Subject: University of Wollongong Molecular and Life Science Building

We should like to make a submission with regard to the above proposed development.

Figure 5.2: University of Wollongong Campus Master Plan

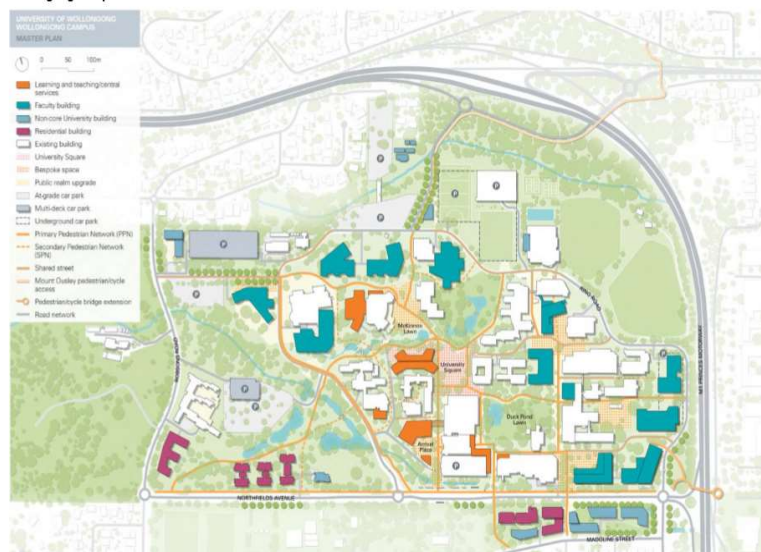
The problem with both the RMS and University access proposals is that the only access is via the existing Mount Ousley Road which will cause more traffic to come via the Princes Highway exit from the M1 motorway from the south. This exit along with the other exits is already highly congested.
